FORMAL ADA/PROWAG CIVIL RIGHTS GRIEVANCE

City of Bloomington, Indiana

East Second Street Pedestrian Access Barrier — Rogers-Binford Elementary School Corridor

Re: ADA / PROWAG Non-Compliance — Inaccessible Pedestrian Route, East Second Street between Eagleson Drive and High Street; No Accessible Route to Rogers-Binford Elementary School

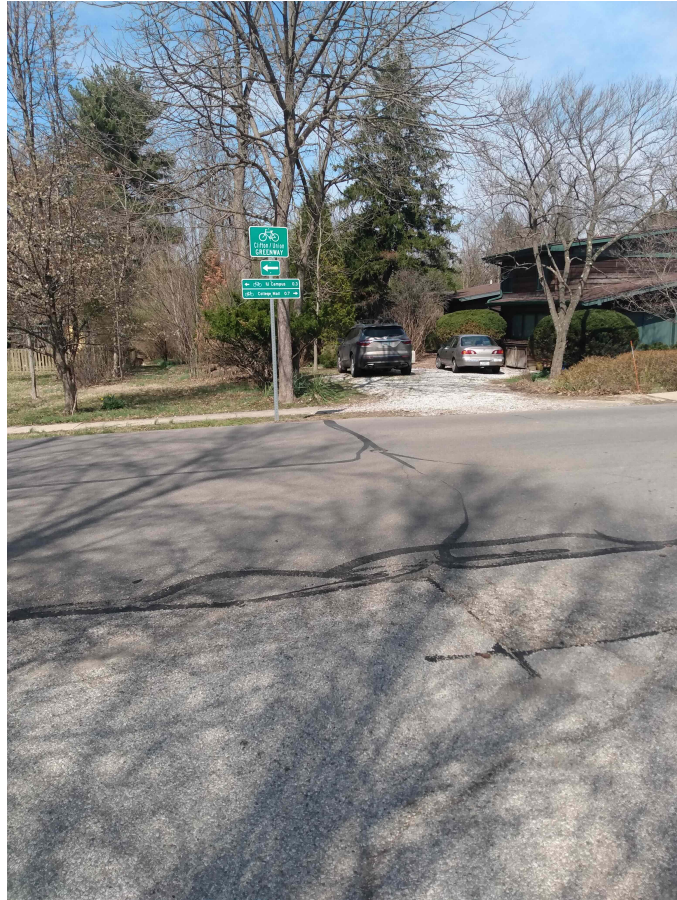
The City has not neglected this location entirely. As documented in Fig. 2 below, the City has installed official bicycle wayfinding signage at this exact location, designating it as part of the "Clifton / Union Greenway." The sign provides distance markers to IU Campus (0.3 miles) and College Mall (0.7 miles), confirming that the City considers this location part of its active transportation network.

- **Demonstrates awareness:** The City knew this location well enough to designate it as part of a named greenway network. It cannot credibly claim ignorance of the gap.
- **Undermines 'undue burden' defense:** The City had resources to plan, design, fabricate, and install greenway wayfinding signage at this exact location. The claim that constructing a sidewalk segment would constitute an undue financial burden is difficult to reconcile with the investment already made in bicycle infrastructure here.
- **Establishes unequal service:** The City actively provides and promotes transportation infrastructure for cyclists at this location while denying equivalent infrastructure for pedestrians with disabilities. This contrast implicates 28 C.F.R. § 35.130(b)(1)(ii) (unequal service) and 28 C.F.R. § 35.130(b)(4) (methods of administration that have a discriminatory effect).

- **Establishes this as a City project, not an oversight:** The greenway sign identifies this location as part of a named City corridor project. The failure to provide an accessible pedestrian route is not an isolated oversight but a deliberate investment decision that excluded accessibility.

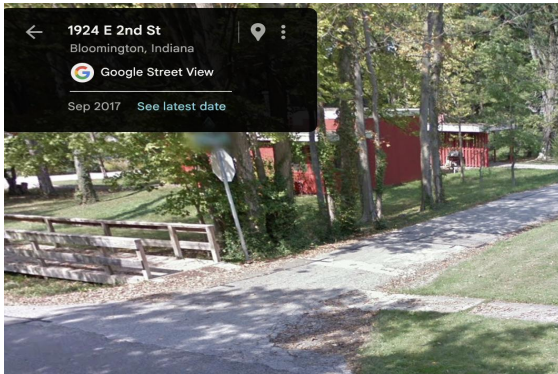
The before-and-after photographs below document the curb ramp installations at the two intersections bracketing the barrier. Google Street View imagery from September 2017 confirms that neither ramp existed at that date. Current photographs confirm that both ramps are now present and include detectable warning surfaces consistent with PROWAG requirements. The installations therefore occurred sometime after September 2017 — after the City formally adopted PROWAG in September 2011.

- **PROWAG R202.2** — The curb ramp installations at S. Anita Street and S. High Street, made under PROWAG, do not satisfy the connection requirement: each ramp connects to a pedestrian circulation path that is impassable rather than to a compliant pedestrian access route.

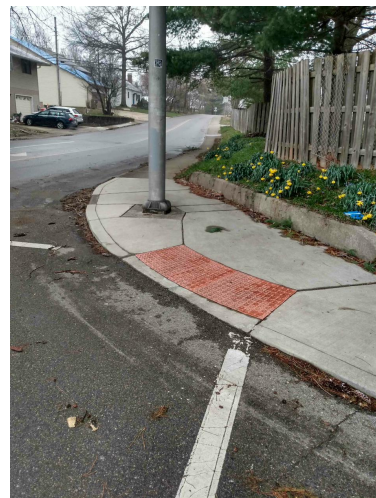
The September 2017 imagery is particularly significant because it documents that the City was aware of conditions on this corridor at that date, including the deteriorated and overgrown sidewalk visible in Fig. 4a at the High Street approach. The decision to install compliant ramps at each intersection while leaving the connecting sidewalk unaddressed was made in full knowledge of the gap.
